Virginia Electric & Power Company
 ATTN: Mr. W. L. Proffitt
 Senior Vice President - Power
 P. O. Box 26666
 Richmond, Virginia 23261

The Commission has issued the enclosed Amendments Nos. 35 and 34 to Facility Operating Licenses Nos. DPR-32 and DPR-37 for the Surry Power Station, Units Nos. 1 and 2, respectively. These amendments include changes to the Technical Specifications for each license in response to your application dated August 9, 1977, as supplemented August 26, 1977, October 14, 1977, and November 16, 1977.

These amendments establish peaking factors $[F_0(Z)]$ to be used when the steam generator tube plugging limit exceeds 19% for Surry Unit No. 1 and 20% for Surry Unit No. 2; in addition, a tube plugging limit of 25% is authorized for both units.

Amendment No. 35
License No. DPR-32

FIGURE 2.1-1 REACTOR CORE THERMAL & HYDRAULIC SAFETY LIMITS-
THREE LOOP OPERATION, 90% DESIGN FLOW

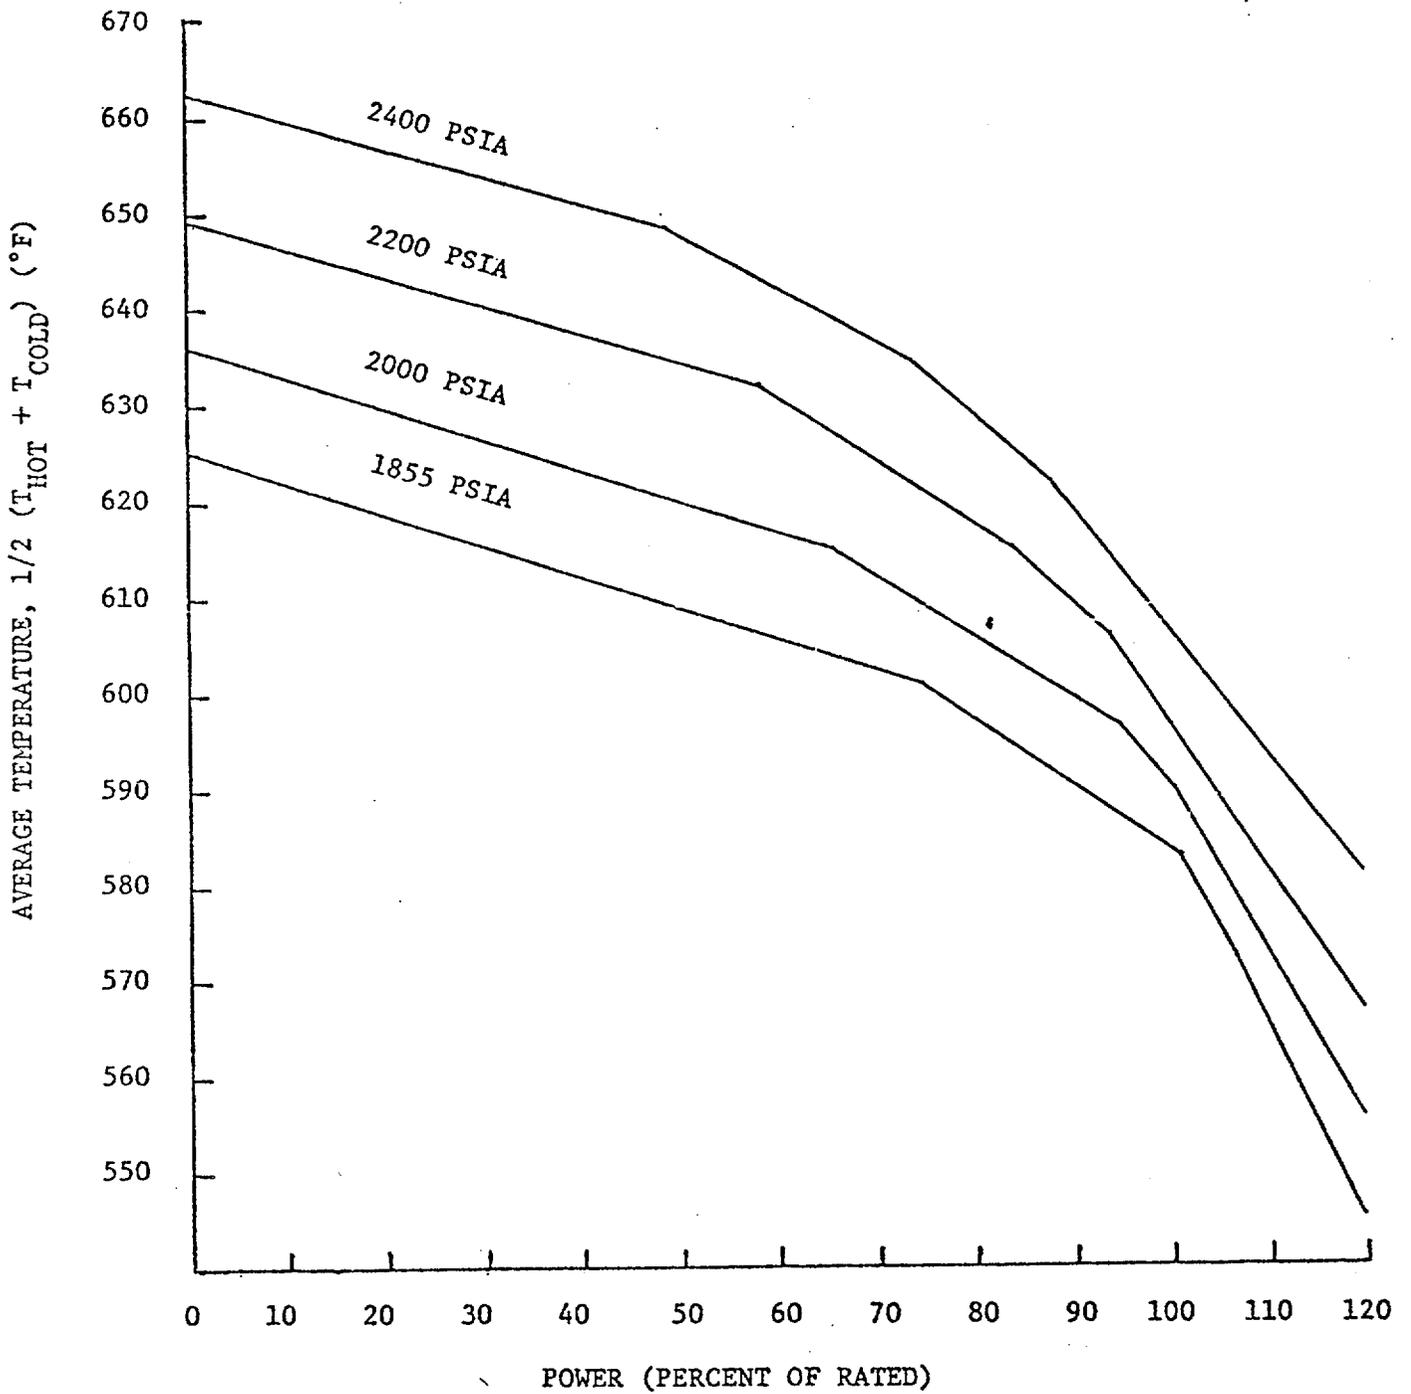
- A. The combination of reactor thermal power level, coolant pressure, and coolant temperature shall not:
1. Exceed the limits shown in TS Figure 2.1-1 when 90% of design flow from three reactor coolant pumps exist.
 2. Exceed the limits shown in TS Figure 2.1-2 when full flow from two reactor coolant pumps exist and the reactor coolant loop stop valves in the non-operating loop are open.
 3. Exceed the limits shown in TS Figure 2.1-3 when full flow from two reactor coolant pumps exist and the reactor coolant loop stop valves in the non-operating loop are closed.

The curves of TS Figure 2.1-1 which show the allowable power level decreasing with increasing temperature at selected pressures for constant flow (three loop operation) represent limits equal to, or more conservative than, the loci of points of thermal power, coolant system average temperature, and coolant system pressure for which the DNB ratio is equal to 1.30 or the average enthalpy at the exit of the core is equal to the saturation value. The area where clad integrity is assured is below these lines. The temperature limits are considerably more conservative than would be required if they were based upon a minimum DNB ratio of 1.30 alone but are such that the plant conditions required to violate the limits are precluded by the self-actuated safety valves on the steam generators. The three loop operation safety limit curve has been revised to allow for heat flux peaking effects due to fuel densification and to apply to 90% of design flow. The effects of rod bowing are also considered in the DNBR analyses.

HOT CHANNEL FACTOR NORMALIZED

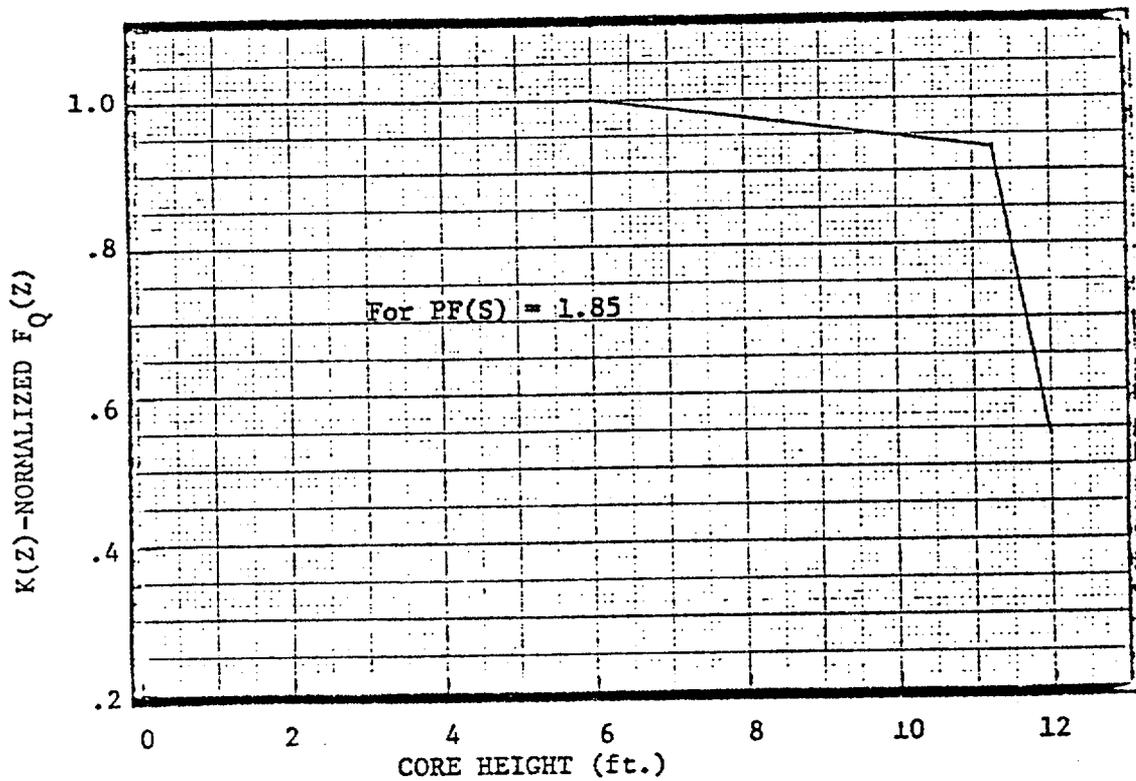
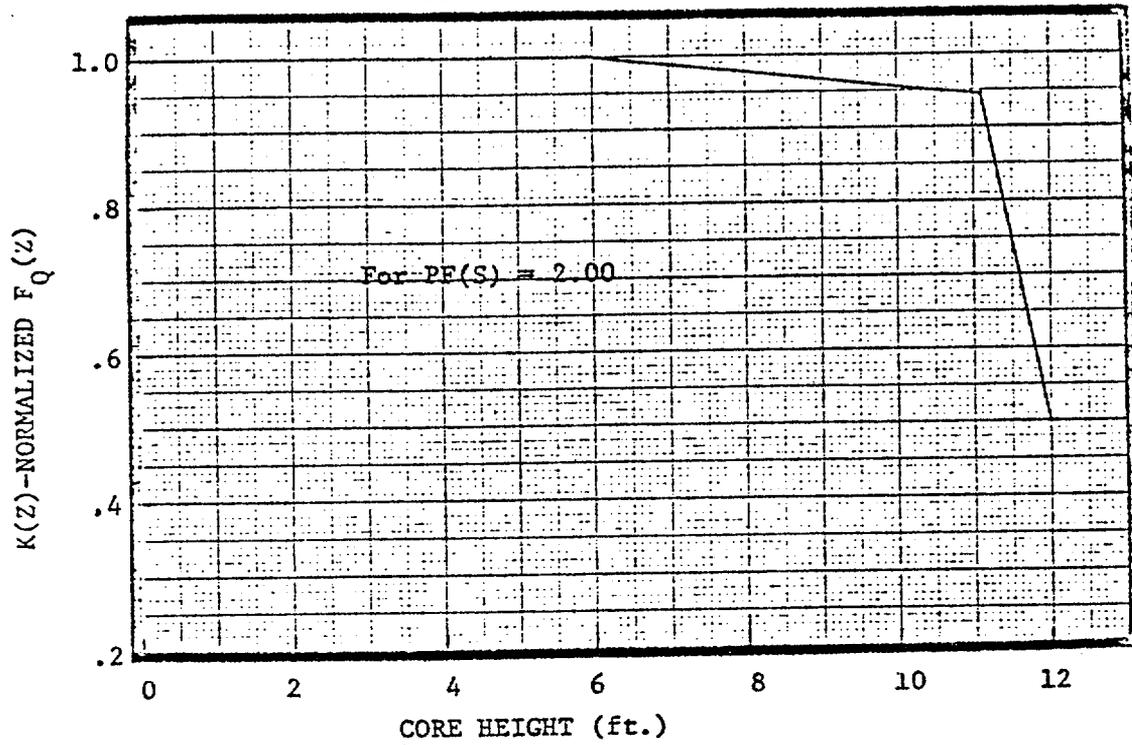
where P is the fraction of rated power at which the core is operating, PF(S) is the function given in TS Table 3.12-2, K(Z) is the function given in TS Figure 3.12-8, Z is the core height location of F_Q, and T(BU) is the interim thimble cell rod bow penalty on F_{ΔH}^N given in TS Figure 3.12-9.

DELETE

FIGURE 2.1-1 REACTOR CORE THERMAL & HYDRAULIC SAFETY LIMITS-
THREE LOOP OPERATION, 90% DESIGN FLOW

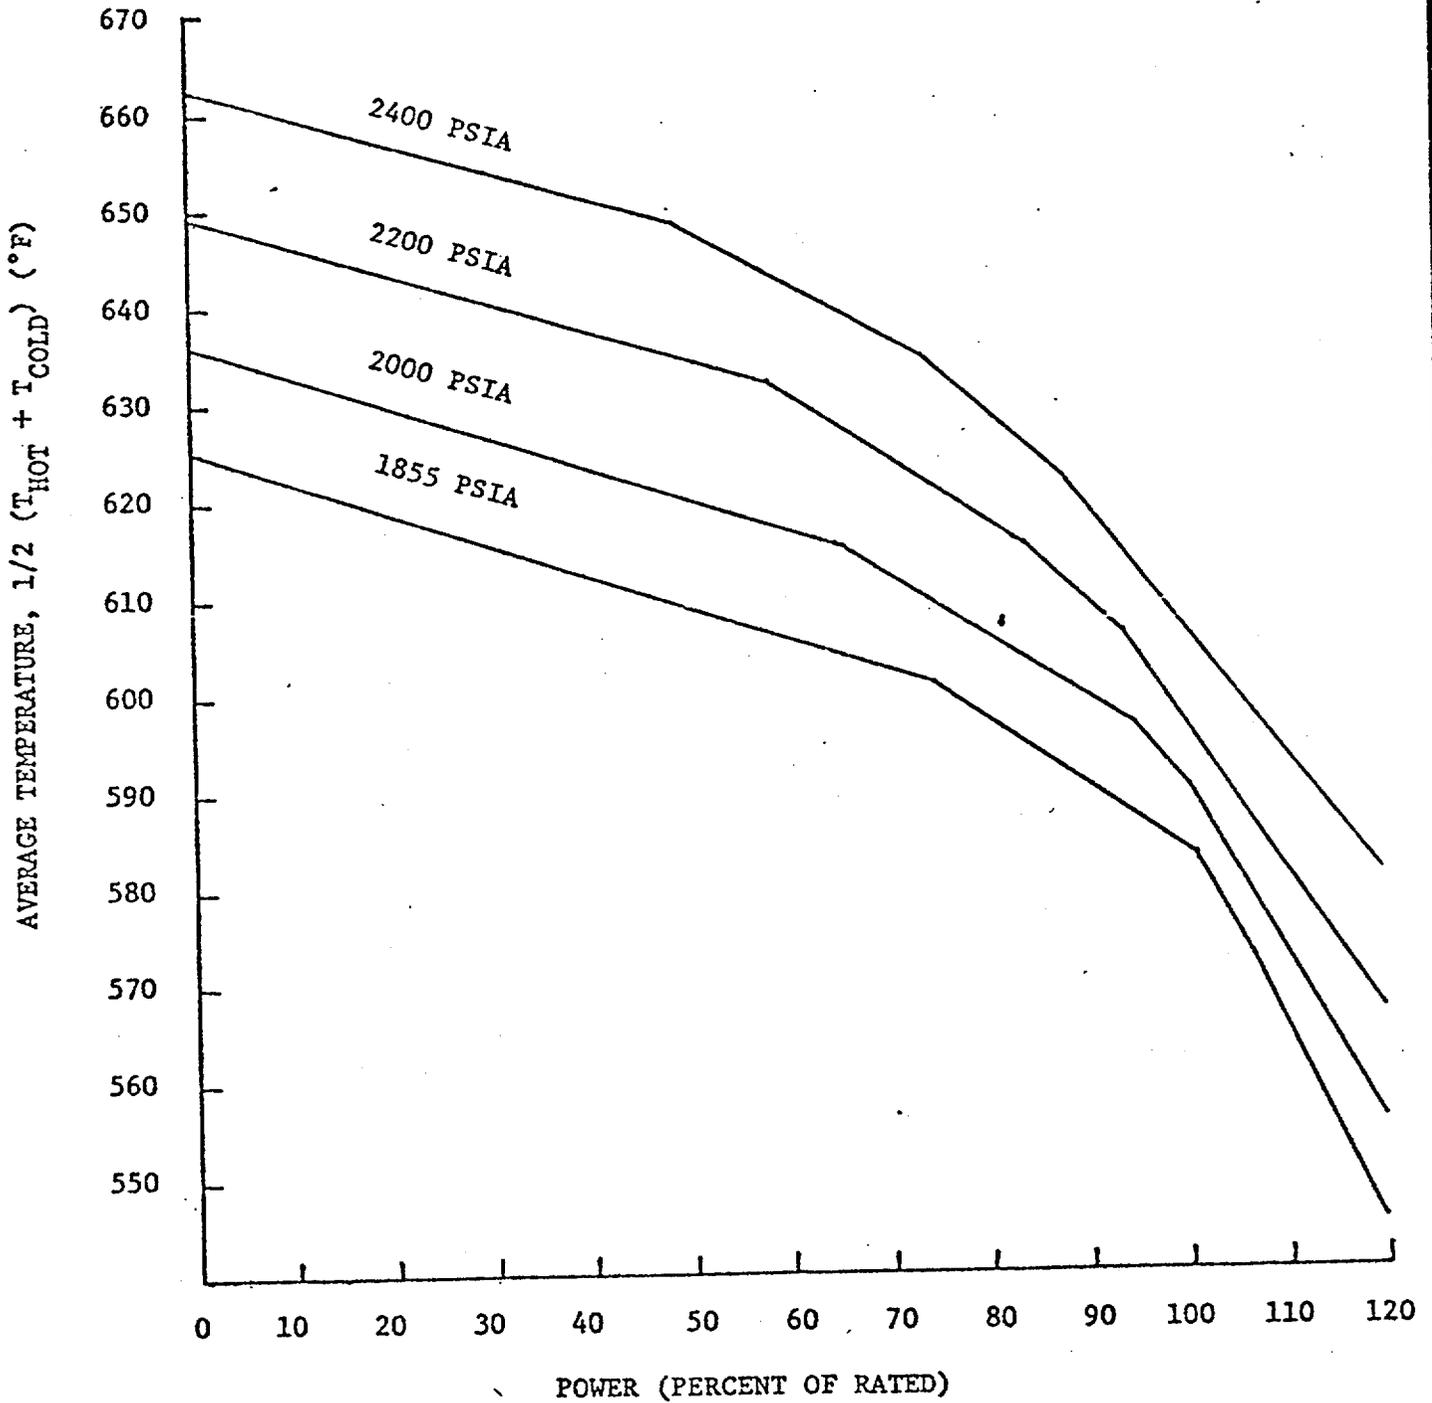
- A. The combination of reactor thermal power level, coolant pressure, and coolant temperature shall not:
1. Exceed the limits shown in TS Figure 2.1-1 when 90% of design flow from three reactor coolant pumps exist.
 2. Exceed the limits shown in TS Figure 2.1-2 when full flow from two reactor coolant pumps exist and the reactor coolant loop stop valves in the non-operating loop are open.
 3. Exceed the limits shown in TS Figure 2.1-3 when full flow from two reactor coolant pumps exist and the reactor coolant loop stop valves in the non-operating loop are closed.

The curves of TS Figure 2.1-1 which show the allowable power level decreasing with increasing temperature at selected pressures for constant flow (three loop operation) represent limits equal to, or more conservative than, the loci of points of thermal power, coolant system average temperature, and coolant system pressure for which the DNB ratio is equal to 1.30 or the average enthalpy at the exit of the core is equal to the saturation value. The area where clad integrity is assured is below these lines. The temperature limits are considerably more conservative than would be required if they were based upon a minimum DNB ratio of 1.30 alone but are such that the plant conditions required to violate the limits are precluded by the self-actuated safety valves on the steam generators. The three loop operation safety limit curve has been revised to allow for heat flux peaking effects due to fuel densification and to apply to 90% of design flow. The effects of rod bowing are also considered in the DNBR analyses.

HOT CHANNEL FACTOR NORMALIZED

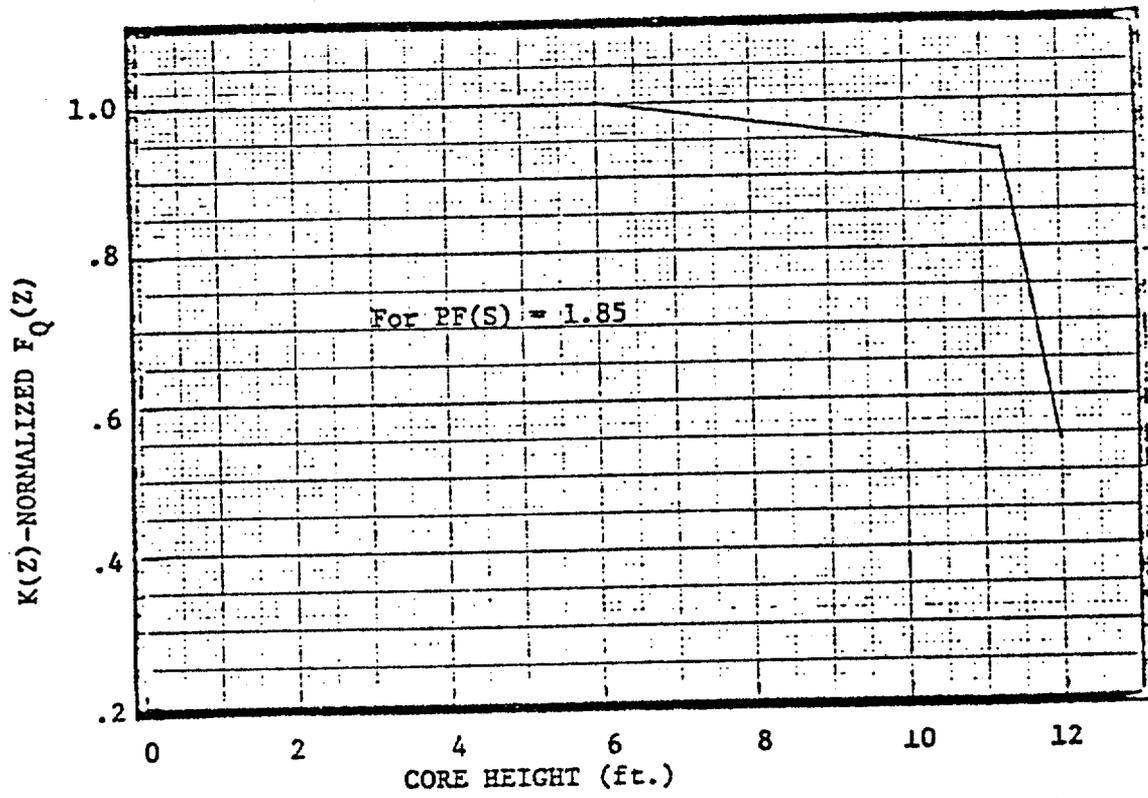
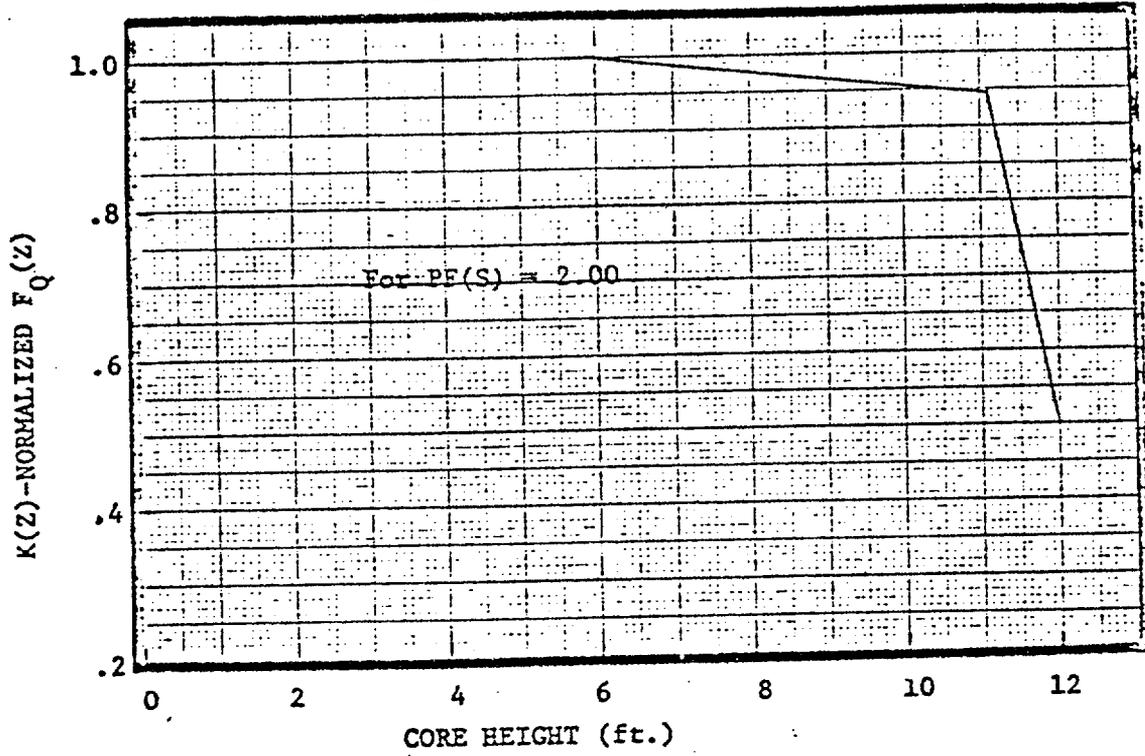
where P is the fraction of rated power at which the core is operating, PF(S) is the function given in TS Table 3.12-2, K(Z) is the function given in TS Figure 3.12-8, Z is the core height location of F_Q, and T(BU) is the interim thimble cell rod bow penalty on F_{ΔH}^N given in TS Figure 3.12-9.

DELETE
